APPLICATION NO.	FILING DATE	FIRST NAMED INVENTOR	ATTORNEY DOCKET NO.	CONFIRMATION NO.
10/527,065	02/09/2006	Martin Guels	101643.55963US	4756

Office Action Summary

DETAILED ACTION

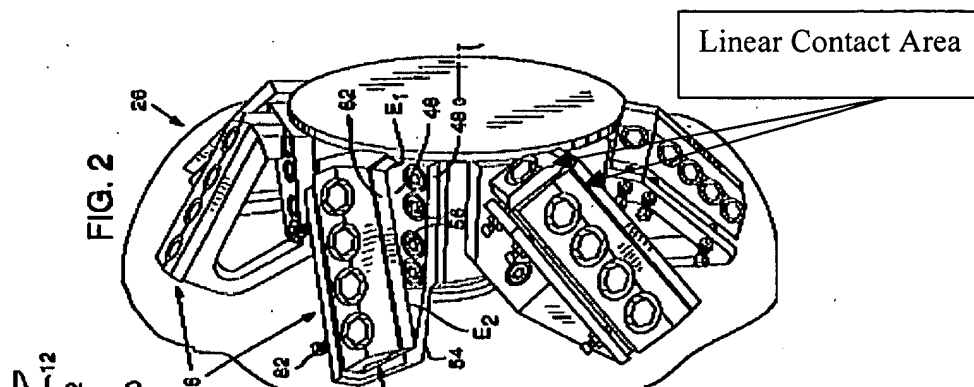
With regard to claim 14, as best as can be understood, Carpenter discloses screws (fig. 2).
